Reference: Nuclear Regulatory Commission [Docket No. 50-361; NRC-2013-00701, Application and Amendment to Facility Operating License Involving Proposed No Significant Hazards Consideration Determination; San Onofre Nuclear Generating Station, Unit 2]

Problem Statement: Two Independent Nuclear Experts Certify that MHI SG Tube Fatigue and Stress Calculations Assumptions are erroneous and based on faulty data – SCE is legally required to certify MHI's calculations to ensure that San Onofre Unit 2 does not pose significant radiological risks at 70% normal steady state power operations during Anticipated Operational Transients and Design Basis Accidents.

SCE Preliminary Response: Dr. Joram Hopfenfeld's Analysis concerning in-plane tube vibration is significantly flawed in that it applies an unreasonably high stress concentration factor based on solid body geometry rather than the more realistic stress concentration factors for a cylindrical geometry applicable to the SONGS steam generator tubes.

Fig-2 Wear Pattern 2

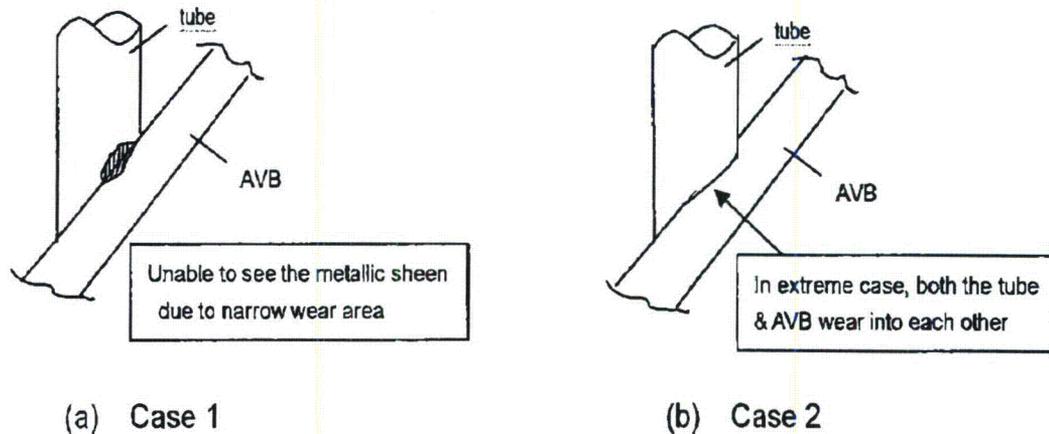
A. In Unit 2 Return to Service Report, Attachment 4, MHI Documents SO23-617-1-M1538, Revision 0, page 288 of 474, Appendix 7, L5-04GA564(9), page 7-9, Figure 2, MHI states, "Section 3.2, Wear Pattern-2 (Local Wear on Tube Surface Characteristics):

(1) Local wear occurs on the tube but the wear surface is not exposed (cannot be seen),

- (2) Unable to determine if wear occurs on tube or AVB or both,
- (3) Unable to determine the direction of motion or vibration, and
- (4) An extreme interpretation is that both tube and AVB are worn into each other.

C. The source of MHI's error described below resulted from how they calculated the increase in the local stress at geometrical discontinuities (notches), which are formed when two metal surfaces come in contact during vibration. Since the worn surfaces of the tubes inside the steam generators as shown in Figure 2 above cannot be seen, MHI made two incorrect key assumptions, which are inconsistent with the observation that both the tube and the supporting bar are worn into each other. First, MHI assumed that the ASME endurance limit could be applied directly to the notched tube surfaces. Since it is commonly known that surface roughness significantly reduces fatigue life and since the ASME data is for smooth polished surfaces, this assumption would underestimate the amount of fatigue damage. Second, when using the Peterson chart, MHI assumed an unrealistically large fillet radius and consequently derived a low concentration stress factor. Large radii would decrease the local stress and cause the tube to fail at a higher level of stress, thereby increasing its fatigue life. Only by using these two, arbitrary, non-conservative-assumptions was MHI able to conclude that Unit 2 did not suffer any fatigue damage.

FIG 1 – COMPARISON OF THE MHI CALCULATED STRESS WITH THE STRESS CALCULATED IN THE CPUC REPORT

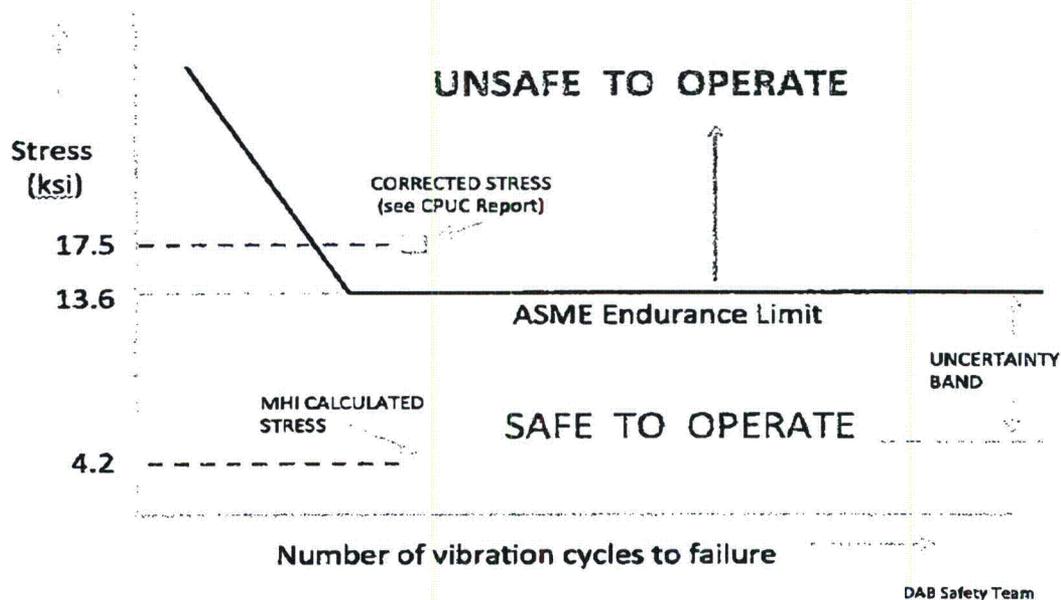
The MHI results are based on two erroneous assumptions. When these assumptions are corrected, as discussed below, the opposite conclusion is reached, which is that the tubes will be susceptible to failure from fatigue.

Fig. 6-4 Wear shape of tube at the contact point with AVB

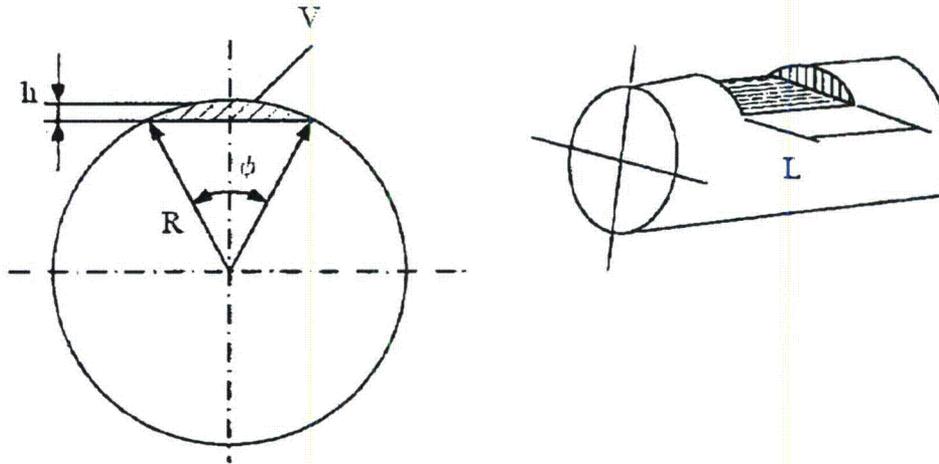
As depicted in the MHI Figure 6-4 below, the support bar and the tube form a sharp discontinuity at the contacting surface, therefore the appropriate geometry for calculating the stress concentration is an abrupt geometry change (very small radii or zero radii of a notch in accordance with RG 1.121), not a large radius shoulder fillet that was assumed by MHI. When a correction is made to account for the sharp notch, the corrected stress indicates (See Figure 1 above) that the tubes have used up their fatigue life during the first cycle of operation. Structures with sharp notches can fail catastrophically when subjected to high cycle fluid elastic instability and flow-induced random vibrations. (MHI redacted their assumption so the exact value of the radius they used is unknown.)

- (Page 10-20, Item (7)) "Wear Calculation: Experimental correlations between the metal loss and the work rate are used to calculate tube metal volume reduction. The relation between wear volume (V) and wear depth (h) is represented as follows: (a) Tube to AVB wear and Tube-to-Tube wear: The tube thickness reduction is then calculated using the wear properties and work rate parameter as assuming the wear configuration as shown in Fig.6-4. The wear width of tube to AVB wear is assumed to be the same as the width of AVB.

Note: Both the impact and the sliding motions play a part in the tube/AVB interaction. These factors reduce tube strength because of material loss and loss of fatigue strength.
